SERVICE BULLETIN

CHECKING OR REPLACEMENT OF THE EXHAUST BEND

ON ROTAX® ENGINE TYPE 914 (SERIES) SB-914-017 R1

fig. 1

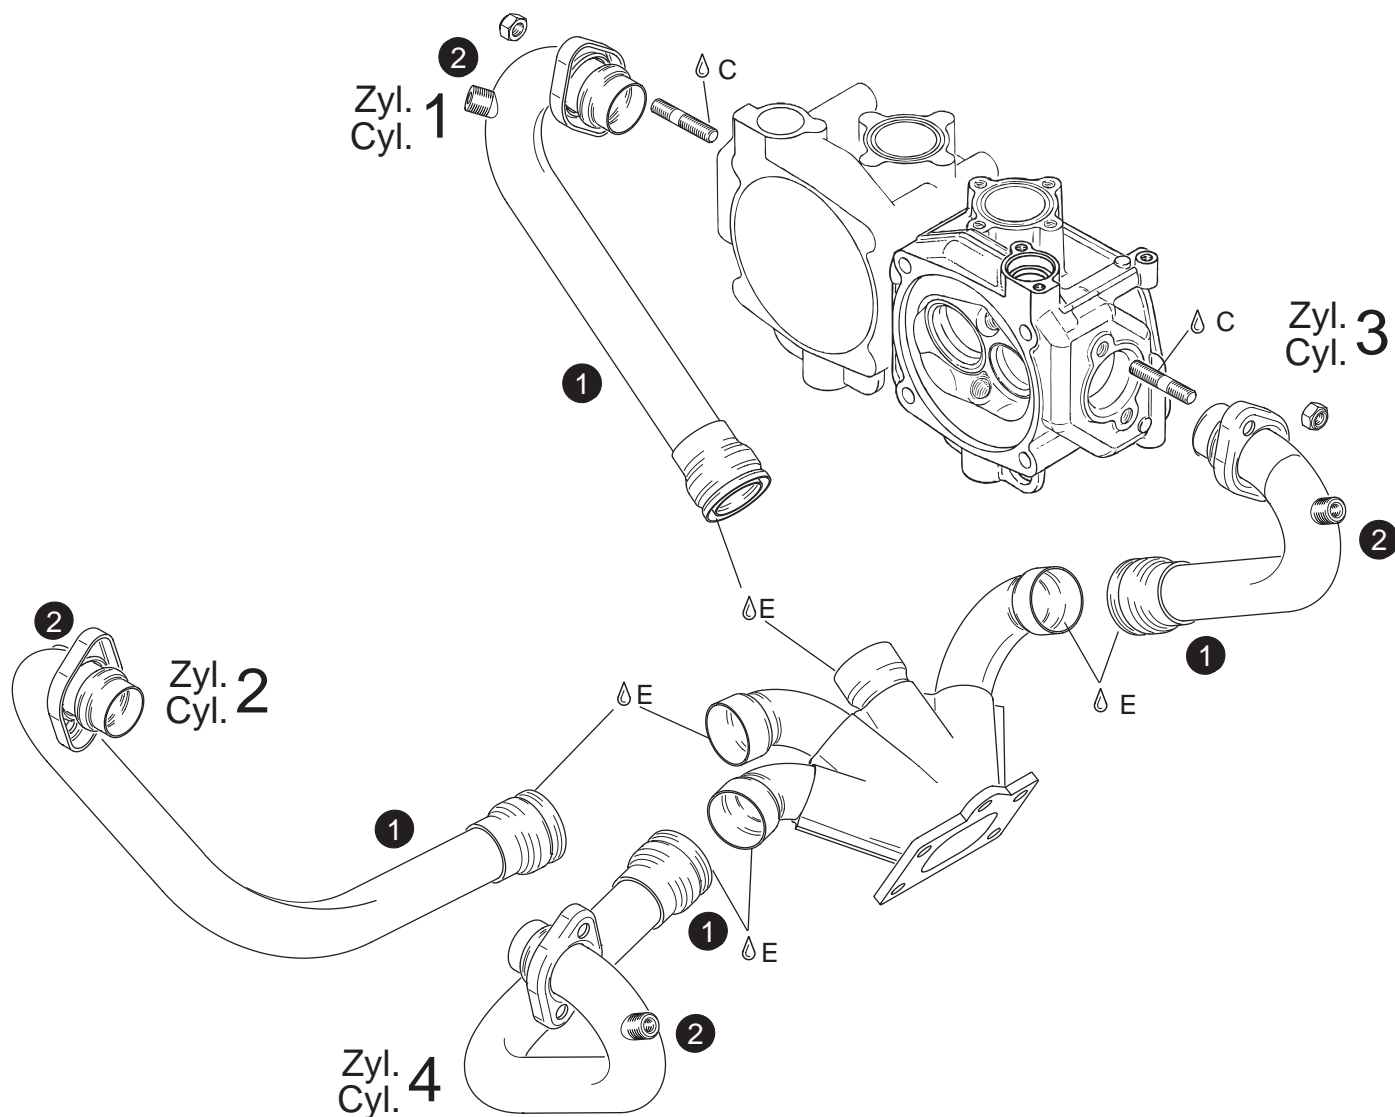
- Inspect the exhaust bends (1) in accordance with the relevant Maintenance Manual.

◆ **NOTE:** Scrutinize the exhaust bends for exterior traces of smoke, cracks and other faults especially about the EGT-terminals (2). (see fig. 1)

- If cracks are detected replace the exhaust bend in accordance with the relevant Maintenance Manual.
